**SONY**  
Broadcast

maintenance and modification information for the one-inch line of Sony Broadcast Products

model: BVH-1000A / BVH-1100A

bulletin no.: 11

Figure 4

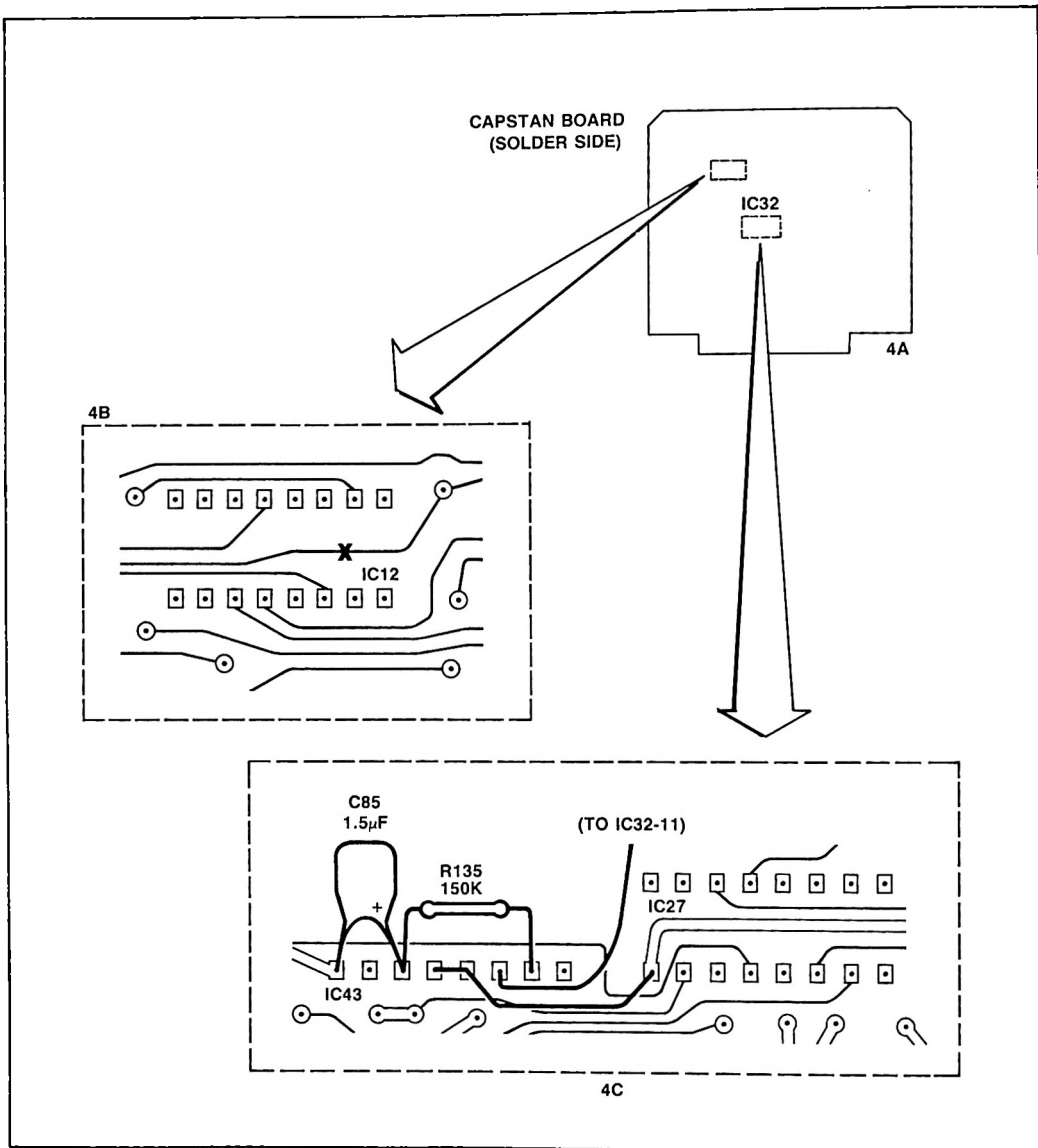
1. Cut the trace between edge connector pin 4B and IC26-5 as indicated in Figure 3B.
2. Cut the trace between IC8-3 and IC32-5 as indicated in Figure 4B.
3. Add the 150KΩ resistor to IC43-2 and -6 as indicated in Figure 4C.
4. Add the 1.5μF capacitor to IC43-6 and ground as indicated in Figure 4C.
5. Jumper IC43-4 and -5 to IC27-8 (Ground) as indicated in Figure 4C.
6. Jumper IC43-3 to IC32-11 as indicated in Figure 4C.

Figure 3. Component Locations and Modification Schematic

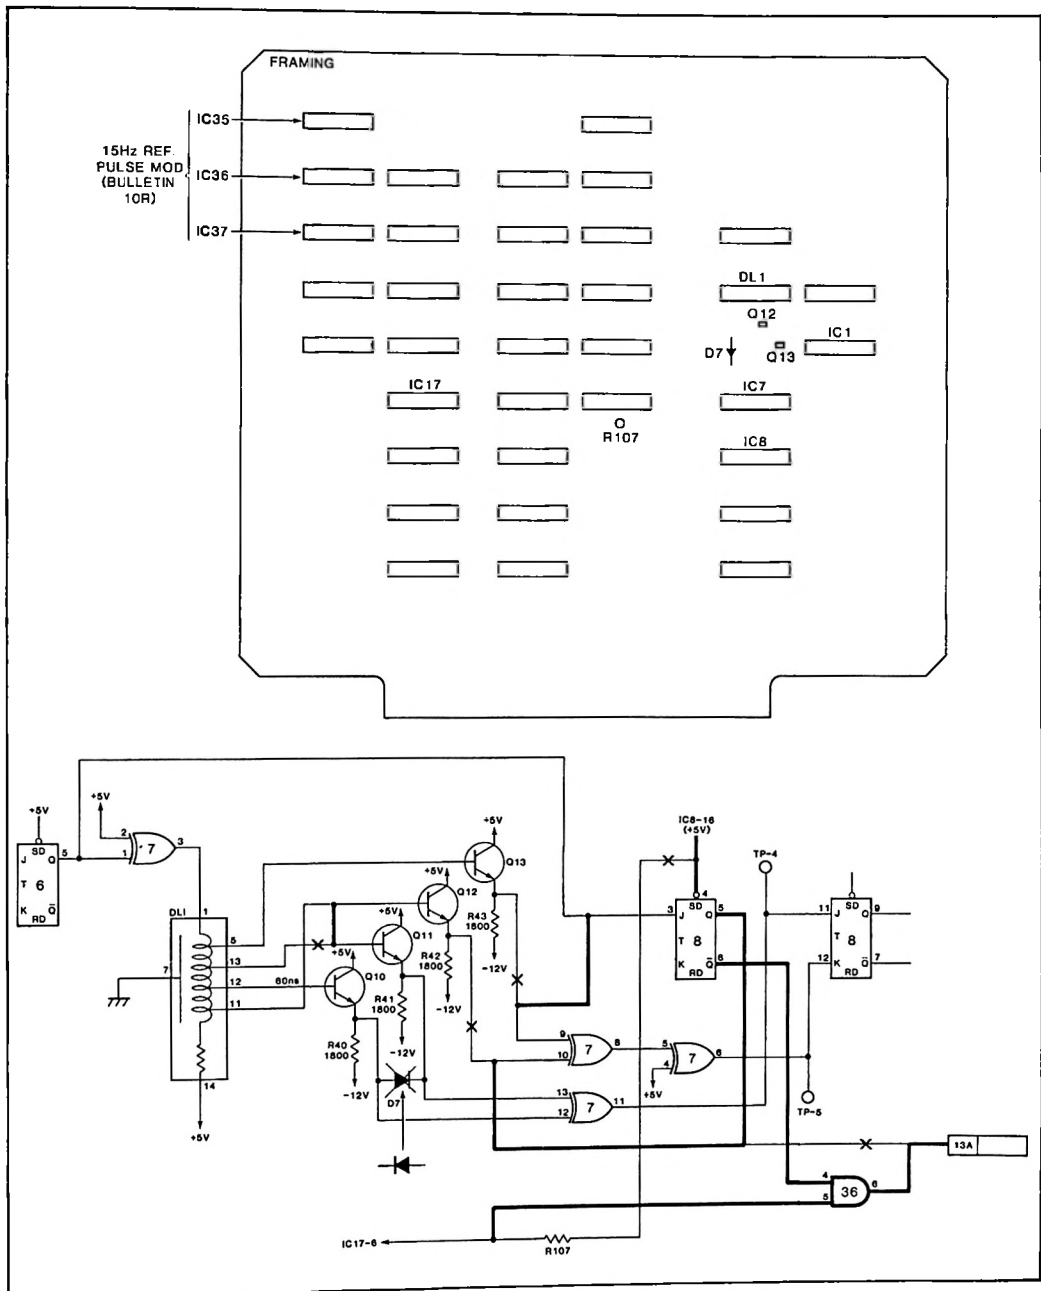
1. Install SN74LS00 and designate as IC36. (See Figure 3.) Pin 7 is ground and pin 14 is +5V.

Figure 2

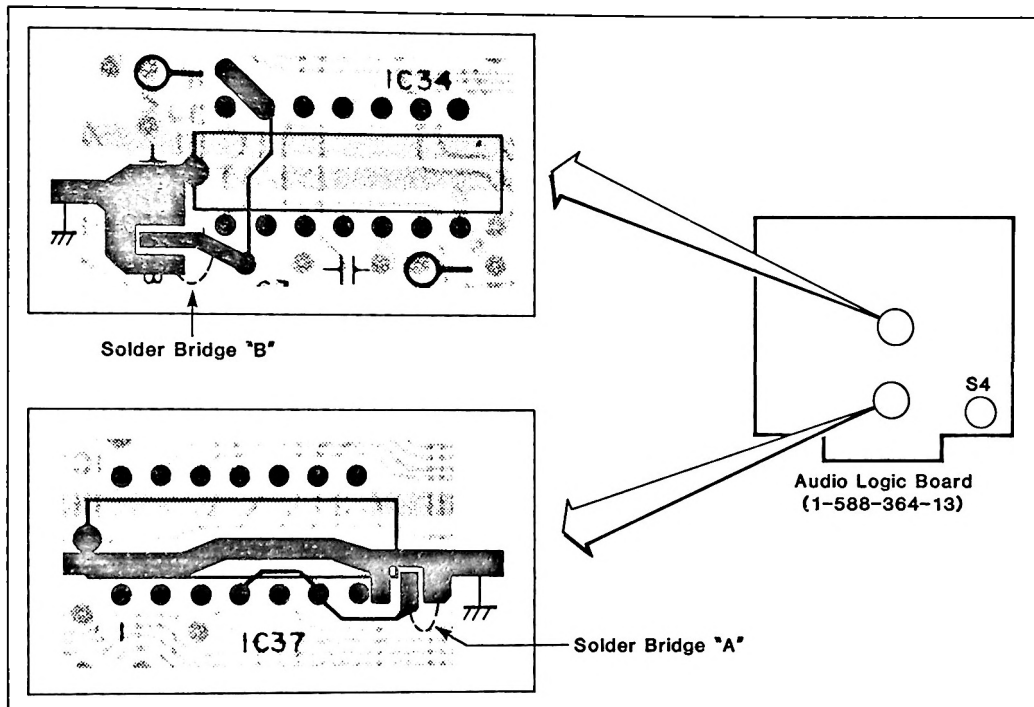
This modification allows the timing of Edit In and Out Commands to establish switch-selectable Field or Frame editing. Various configurations can be established, depending on the position of switch S4 and the selection of "A" and "B" solder bridges. (See Figures 1 and 2.)

Figure 3

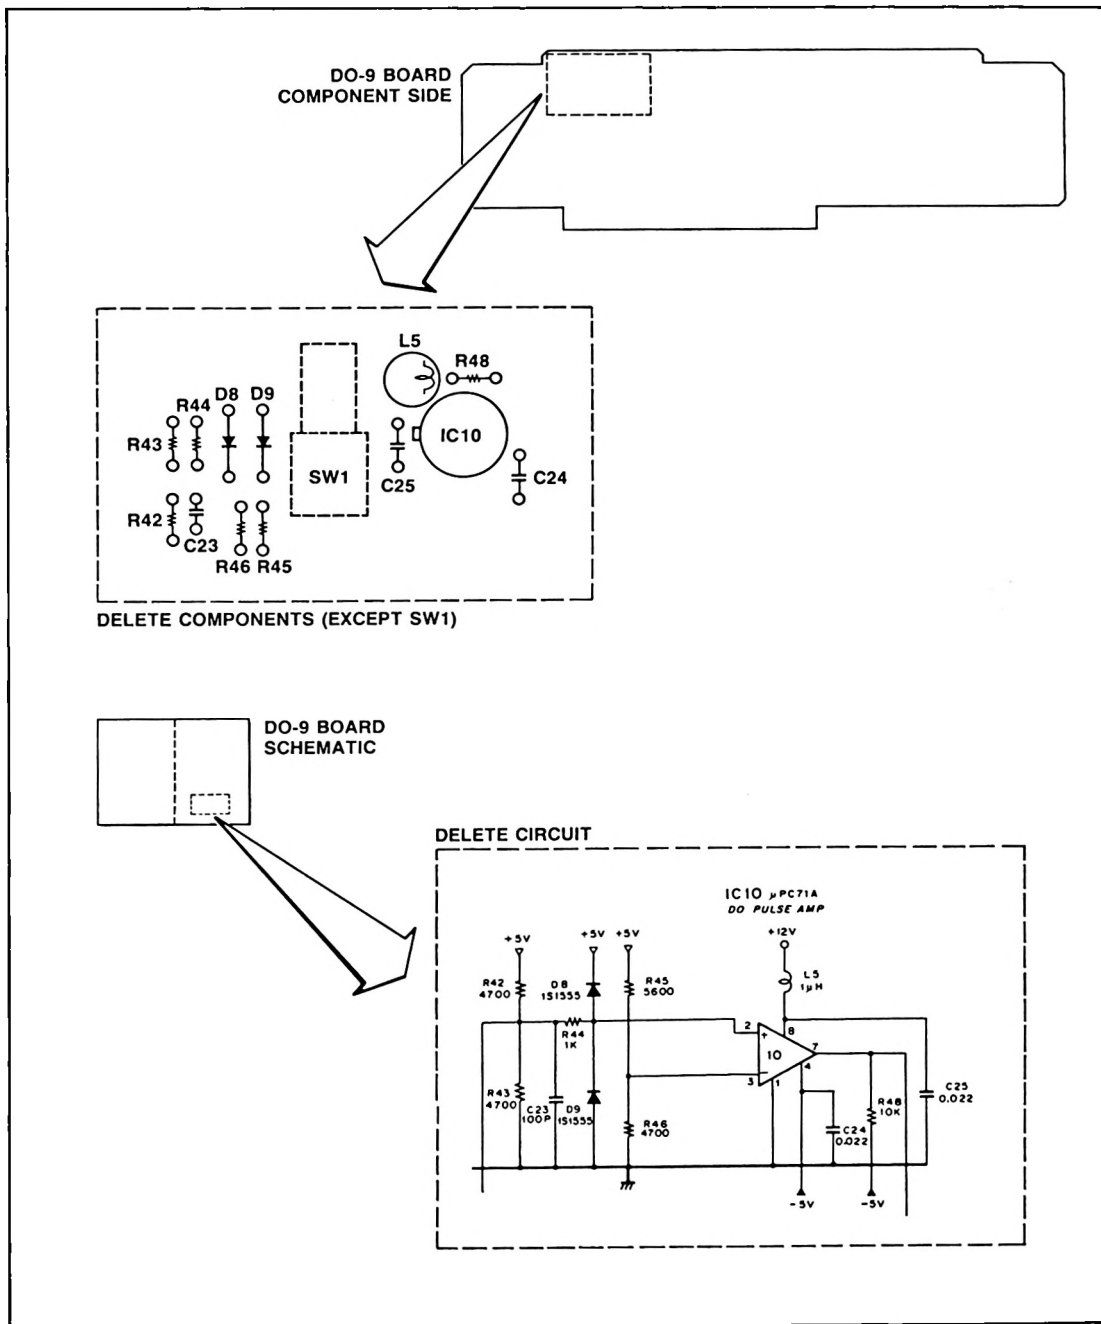
1. Remove following components (See Figure 3.):

Figure 4

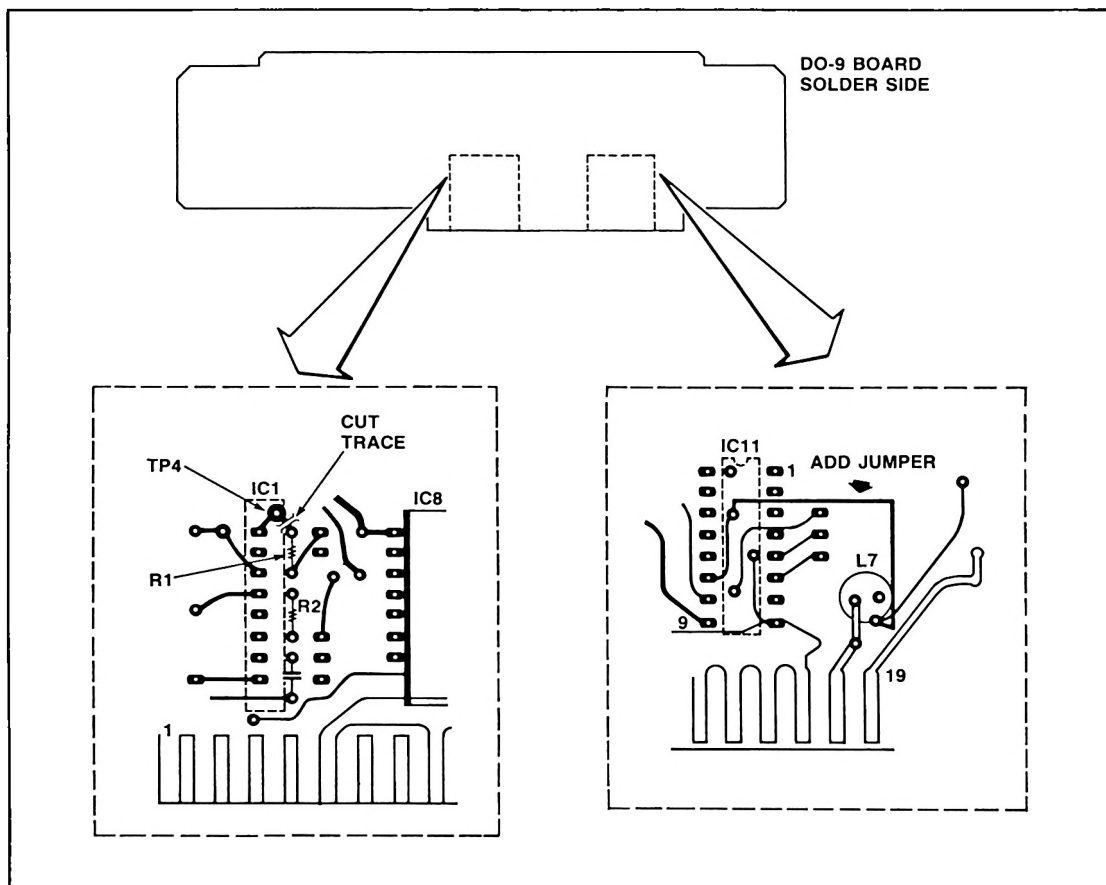
2. On solder side, jumper IC11-11 to CN102-P as shown in Figure 4.
3. On solder side, cut trace between TP4 and R1.
4. Install new circuit illustrated in Figure 6 in space provided by Step 1.

**Figure 1**

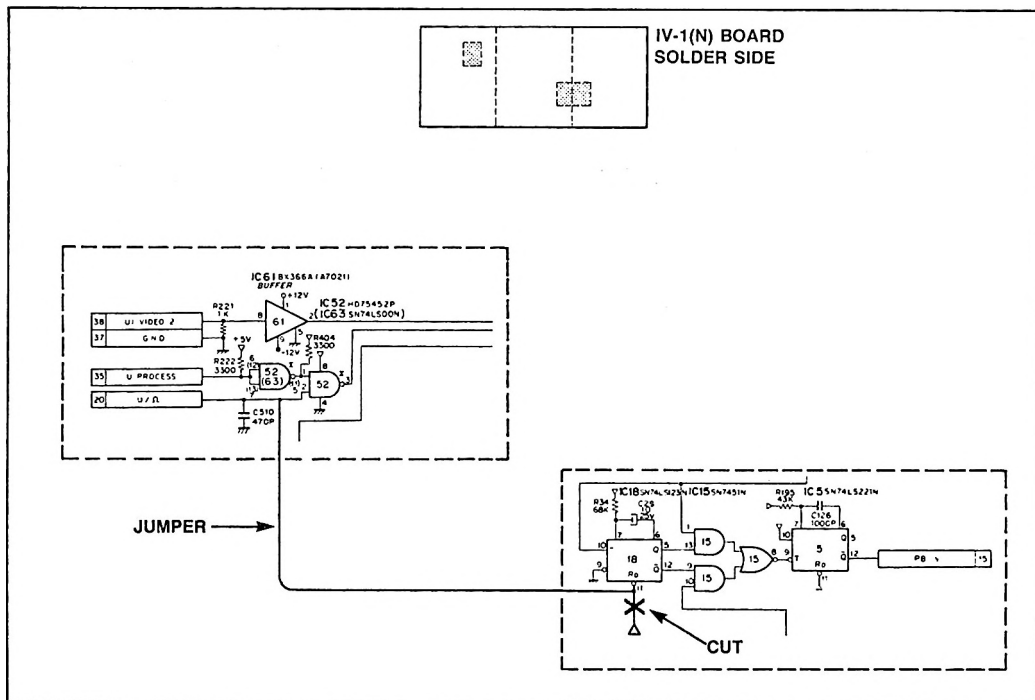
The modification shown in Figure 1 will cause the TBC to use the "1st EQ Pulse Detector" whenever a 1" VTR is used for playback.

**Figure 1**

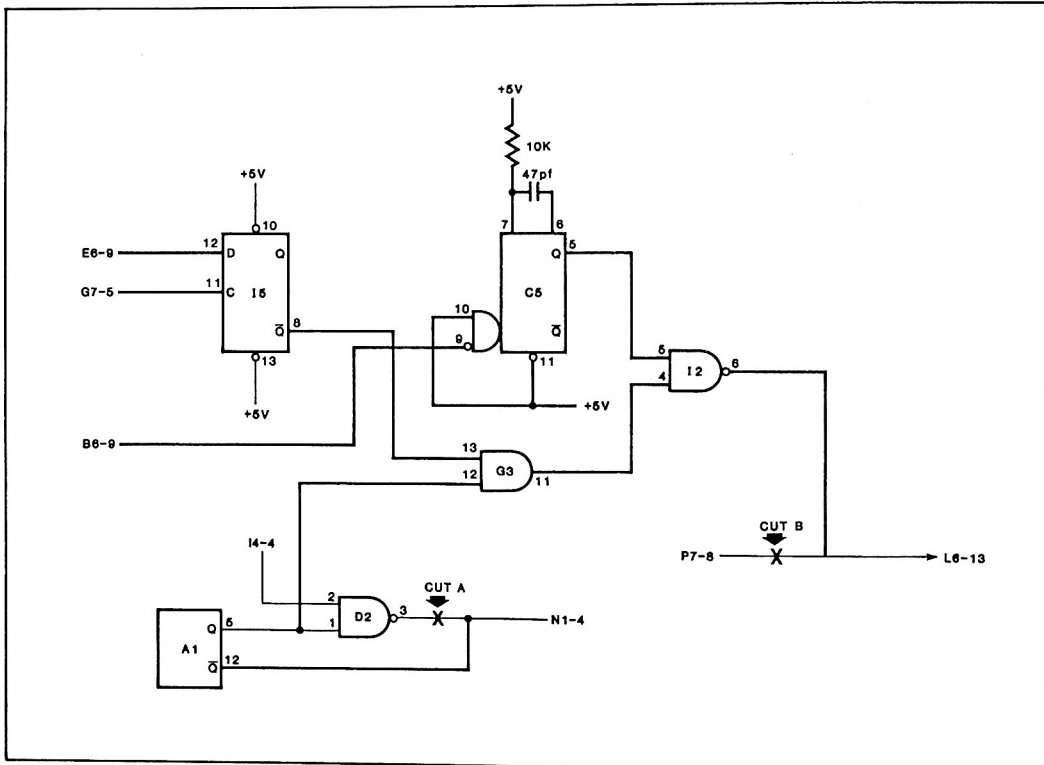
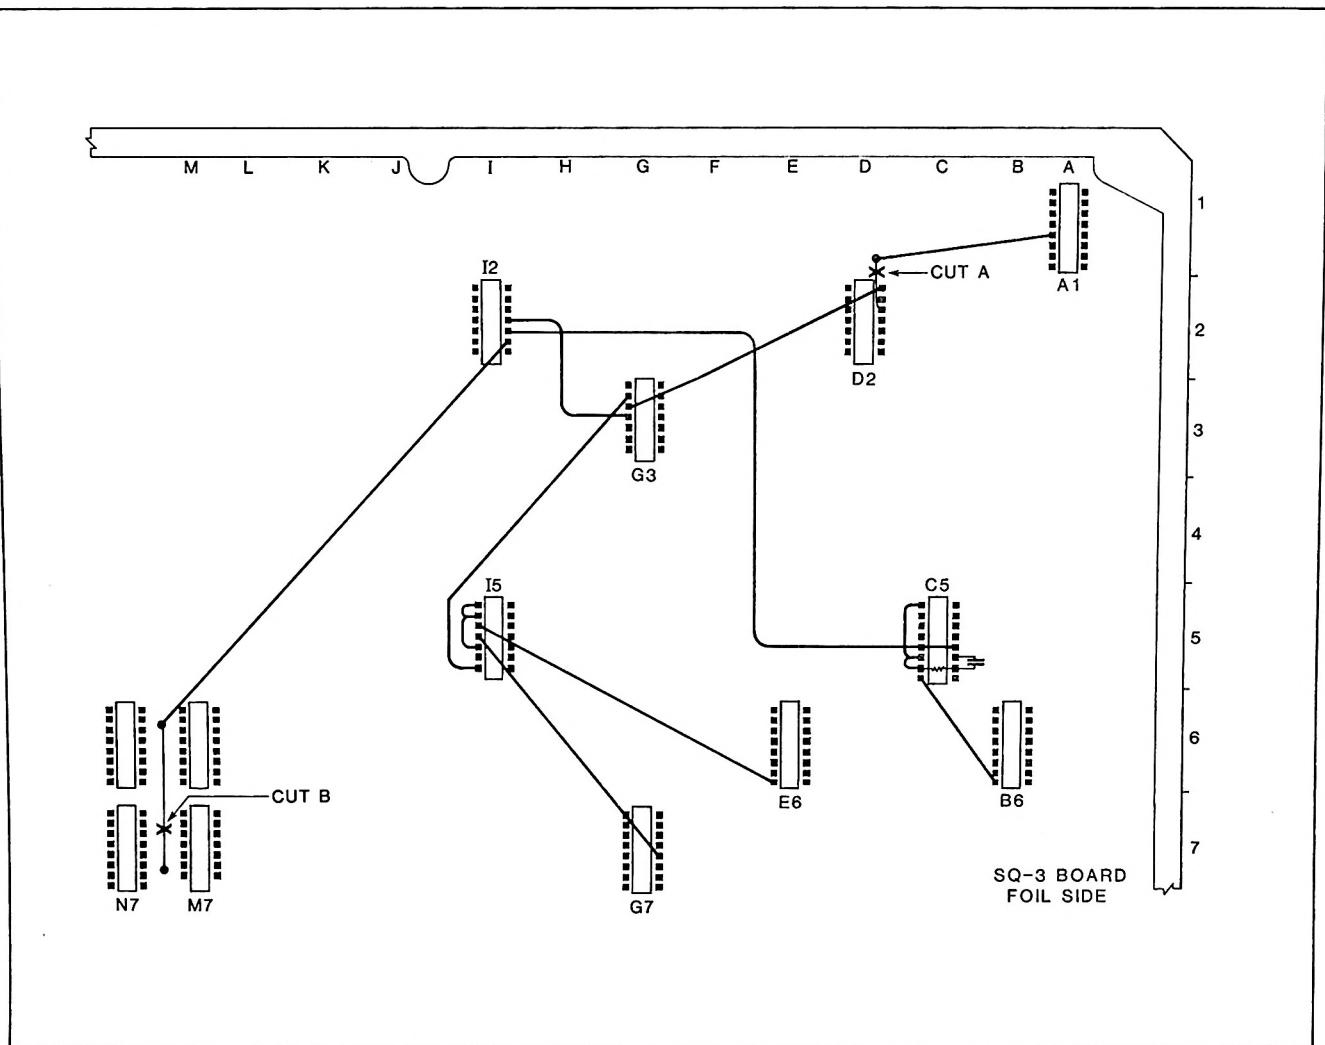
1. On foil side of SQ-3 Board, add the following jumpers. (See Figures 1 and 2.):

2. Connect 10k resistor between C5-7 and C5-10 (+5V).
3. Connect 47 pF capacitor between C5-6 and C5-7.
4. Cut trace between D2-3 and N1-4 (Cut A, Figure 2).
5. Cut trace between O7-8 and L6-13 (Cut B, Figure 2).
6. On component side, adjust VR17 (location F8) and VR3 (location B1) fully CCW.

Figure 2

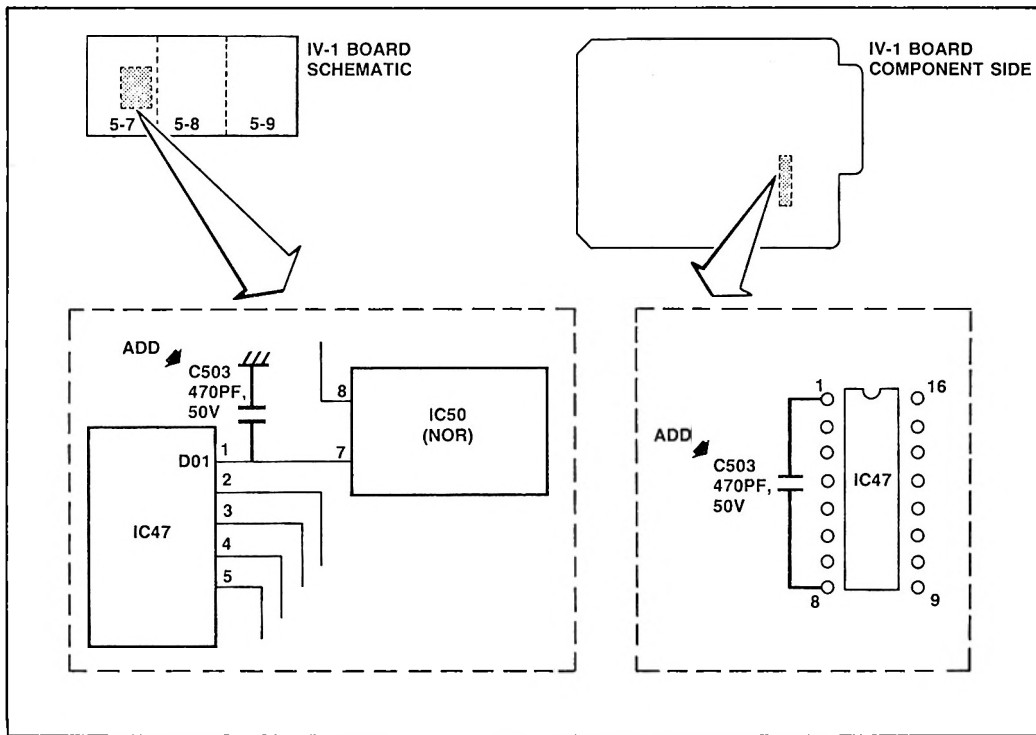
**IV1- Board (See Figure 2.)**

Figure 2

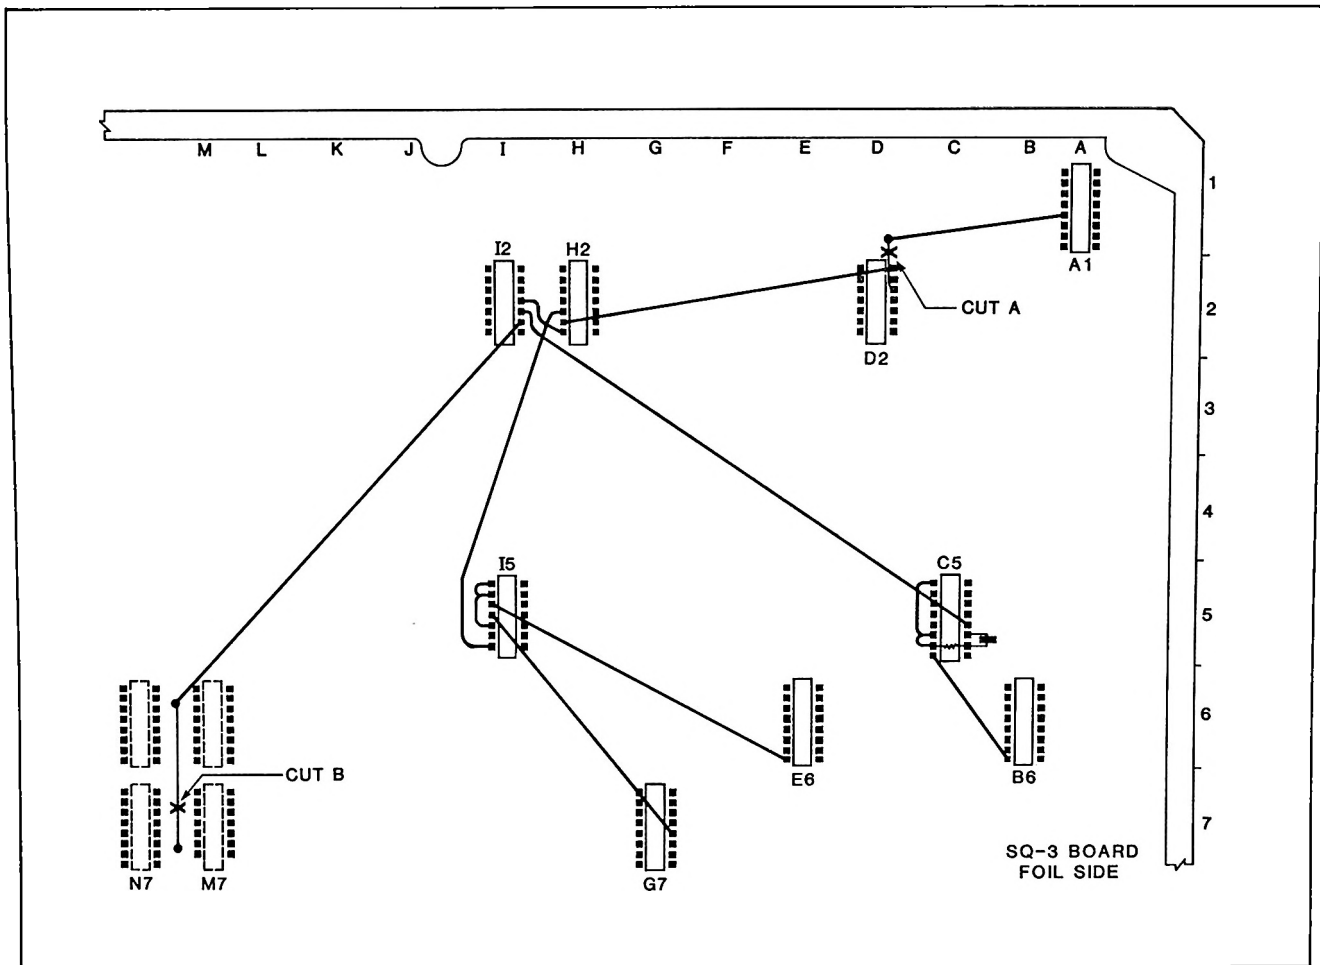
5. Cut trace between O7-8 and L6-13 (Cut B, Figure 2).
